**ORDINANCE NO. 1770**

**AN ORDINANCE AMENDING ORDINANCE NO. 1253 KNOWN AS THE ZONING ORDINANCE AND ORDINANCE NO. 1402: A PLANNED UNIT DEVELOPMENT KNOWN AS THE IDLEWILD PLACE PUD**

**DATE:** January 23, 2023  
**TO:** Fairhope City Council  
**FROM:** Hunter Simmons, Planning Director  
**RE:** Idlewild PUD (ZC 22.06)

## ZC 22.06 - Idlewild PUD Amendment

Proposed PUD Amendment – Site Plan

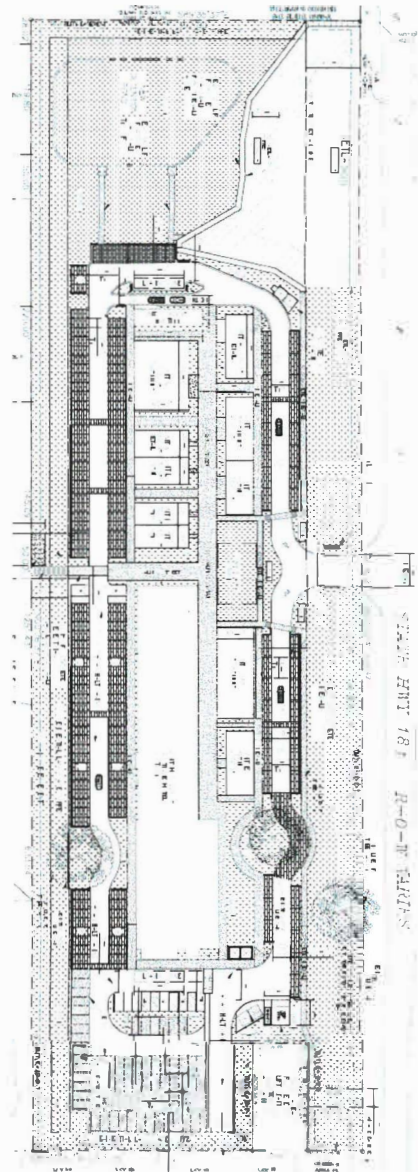
Ordinance 1402 was approved in 2009. In the last thirteen years, the property changed owners but has not been developed. The applicant is requesting a modification of the PUD to reflect a different approach to commercial development at this location. In essence, the proposed PUD amendment is a completely new design. Both the approved and proposed site plans are shown below-

The PUD amendment proposes twelve commercial or mixed-use buildings on site. The owner plans to enter leasehold agreements for all commercial spaces and residential units. The provided site plan and Master Development Plan define the following development standards and conditions:

Setbacks: Front (Hwy 181) – 60'; Rear – 20'; Side – 20'

Screening: A 20' drainage easement and a 20' landscaped buffer (40'total) shall separate the PUD from the adjacent residential lots. Said screening shall be installed per the Landscape Ordinance and the Zoning Ordinance at time of application. A 60' construction setback shall separate the PUD from US Highway 181.

Exterior Lighting: Lighting height was described in the landscape packaging as ranging from 14' to 24'. The Zoning Ordinance requires parking lots with more than 50 spaces to limit lighting height to 20 feet. Since this is a PUD, staff is amenable to a 24' maximum height as long as light shielding and foot-candle requirements are met.

Parking: 228 parking spaces are proposed. 276 are required to meet the Zoning Ordinance. Applicant has provided a draft parking agreement for shared parking.

Hours of Operation: Hours of operation were not provided for the proposed drive thru. Staff recommends hours of operation for the drive thru, at minimum, be provided.

1. A revised Greenspace Plan will be required for staff review prior to City Council.
2. A revised Master Development Plan will be required for staff review prior to City Council.
3. Provide a strong landscape buffer, such as evergreens, to provide screening from light pollution to be reviewed at time of Multiple Occupancy Project approval.
4. Rear setback shall be 40'. Front setbacks shall be as shown on the Site Plan, applicant shall supply dimension prior to City Council hearing.

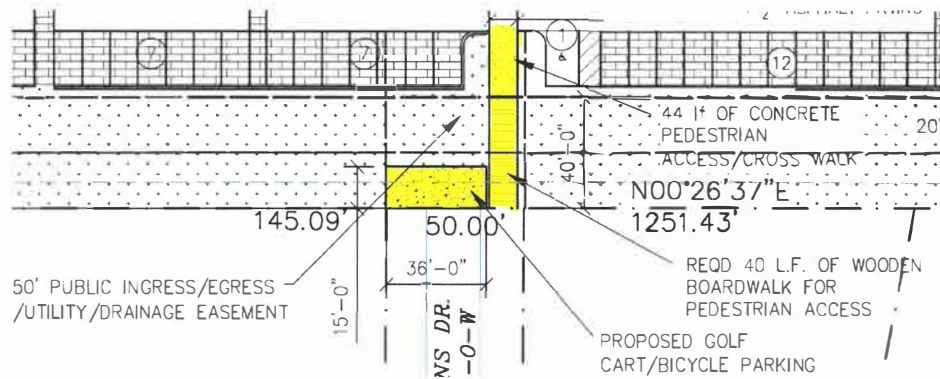
**Connectivity:** a boardwalk and sidewalk are proposed from the northern boundary to the southern boundary. An 50' ingress/egress/utility easement has been added from Orleans Drive to the proposed internal road. Orleans Drive is not proposed to connect to the development at this time. Golf cart parking is proposed in the drainage easement and a pedestrian bridge is shown from Orleans Drive to the development. Staff The proposed golf cart parking and pedestrian bridge are shown below:

1. The boardwalk landings needed to cover the outfalls into the detention pond are shown to stop over dry land. Boardwalk amenity shall extend over the drainage pond. Boardwalks shall be connected to each other in a manner subject to Planning staff approval.
2. The walkway canopy shown with the hotel shall be constructed at a height that can be cleared by delivery trucks.
3. Golf cart parking in the drainage easement needs to be clarified. A stormwater pipe may be required beneath this improvement.
4. Staff would like the engineer to explain the grading across the trees.
5. The proposed hotel parapet height (38.5') seems high for a maximum 2-story building. Staff would like clarification.
6. Proposed building materials indicate painted siding. What is the proposed siding?
